Product Bulletin

Use of 15KW Heat Kits on 3T FLEXX Air Handlers

Reference: FLEXX 3-ton Air Handlers with 15KW Electric Heat Kit

Models Affected: FLEXX36HP230V1BH

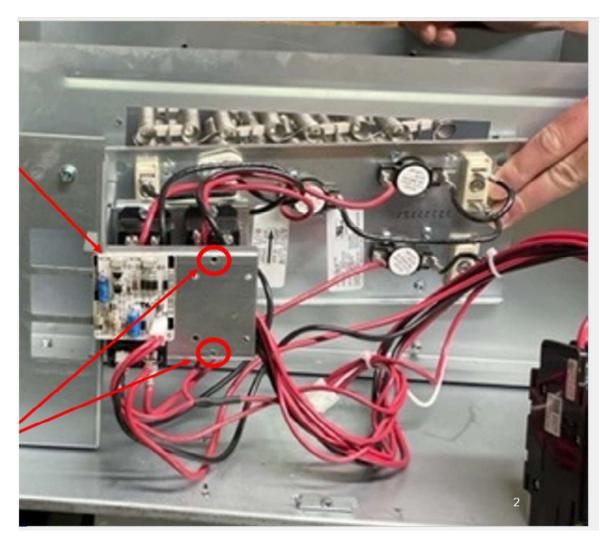
The location of the heat sequencer on the heat kit hinders the installation of a 15KW heat kit in model FLEXX36HP230V1BH.

For the installation of the 15KW heat kit, please follow these steps:

- 1. Before work, please ensure the power has been disconnected.
- 2. Remove the two screws located at the top and bottom of the heat sequencer.
- 3. Using the two identical holes directly to the right, partially install the lower screw.
- 4. Slide the heat sequencer onto the lower screw.
- 5. Install the upper screw and tighten the lower screw.
- 6. Complete the installation of the heat kit as normal.

Sequencer has been moved and mounted using the two screws providied with the sequencer and the two pre-drilled screw holes on the right
